The Commission has issued the enclosed Amendment No. 86 to Facility Operating License No. DPR-32 and Amendment No. 87 to Facility Operating License No. DPR-37 for the Surry Power Station, Unit Nos. 1 and 2, respectively. The amendments consist of changes to the Technical Specifications in response to your application transmitted by letter dated November 22, 1982.

These amendments revise the Technical Specifications to restore the core thermal limits and overtemperature and overpower ΔT setpoints to values consistent with 100% of thermal design flow.

ATTACHMENT TO LICENSE AMENDMENTS

SAFETY EVALUATION BY THE OFFICE OF NUCLEAR REACTOR REGULATION
RELATED TO AMENDMENT NO. 86 TO FACILITY OPERATING LICENSE NO. DPR-32
AND AMENDMENT NO. 87 TO FACILITY OPERATING LICENSE NO. DPR-37
VIRGINIA ELECTRIC AND POWER COMPANY
SURRY POWER STATION, UNIT NOS. 1 AND 2
DOCKET NOS. 50-280 AND 50-281

FIGURE 2.1-1 REACTOR CORE THERMAL & HYDRAULIC SAFETY LIMITS-
THREE LOOP OPERATION, 100% FLOW

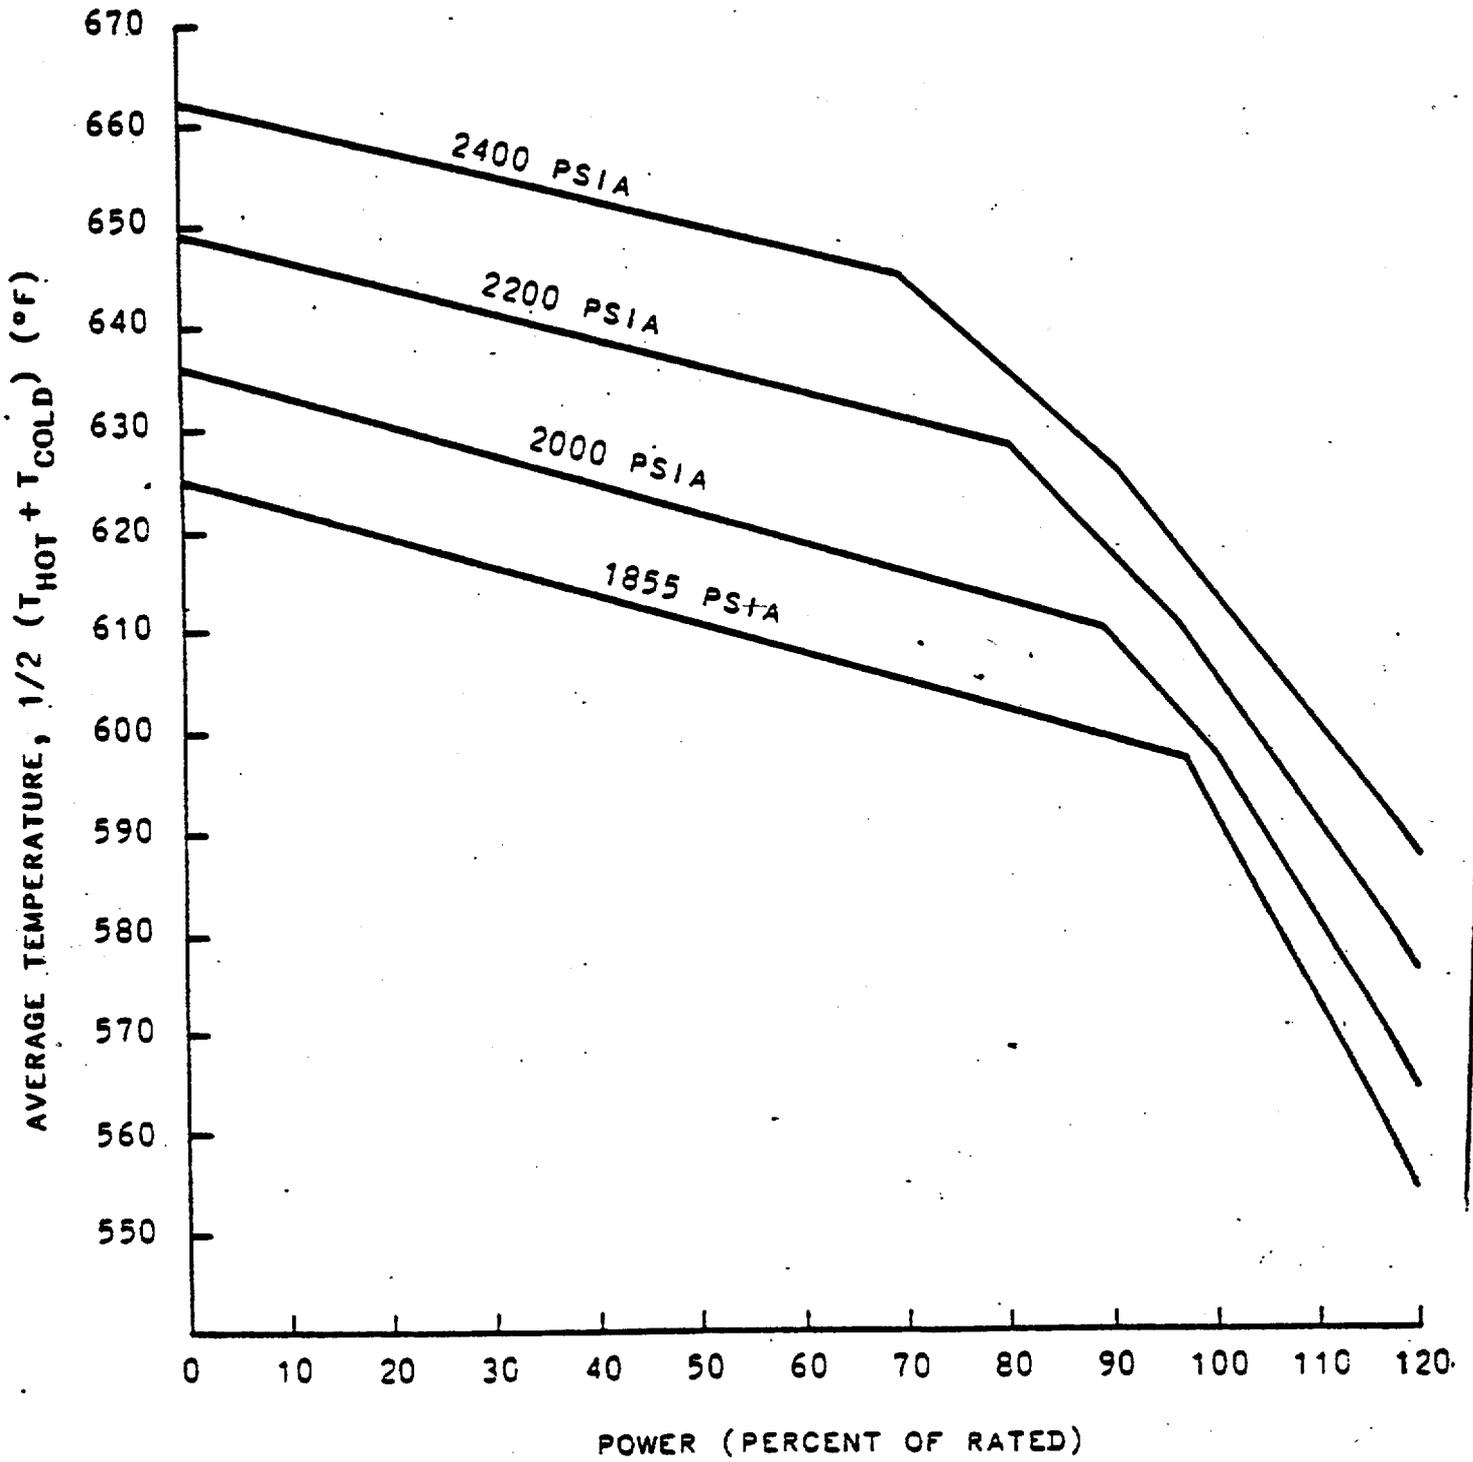
The curves of TS Figure 2.1-1 which show the allowable power level decreasing with increasing temperature at selected pressures for constant flow (three loop operation) represent limits equal to, or more conservative than, the loci of points of thermal power, coolant system average temperature, and coolant system pressure for which the DNB ratio is equal to 1.30 or the average enthalpy at the exit of the core is equal to the saturation value. The area where clad integrity is assured is below these lines. The temperature limits are considerably more conservative than would be required if they were based upon a minimum DNB ratio of 1.30 alone but are such that the plant conditions required to violate the limits are precluded by the self-actuated safety valves on the steam generators. The three loop operation safety limit curve has been revised to allow for heat flux peaking effects due to fuel densification and to apply to 100% of design flow. The effects of rod bowing are also considered in the DNBR analyses.
